Video Products Technical Bulletin 30-2006-088

SUBJECT: **REUSE ICs WHEN REPLACING YA BOARD**

MODEL: **VPH-G90E**
VPH-G90M
VPH-G90U

Figure 1

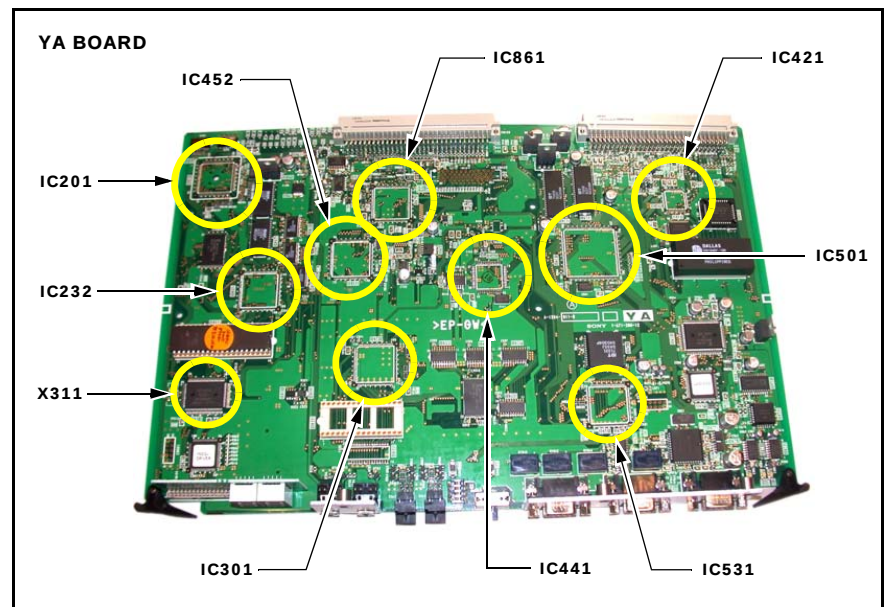
When you replace the YA board (A-1394-911-A/B), remove the following ICs from the former board and install them on the new board.

The new YA board does not contain the ICs, which are no longer available as service parts. (See Figure 1.)
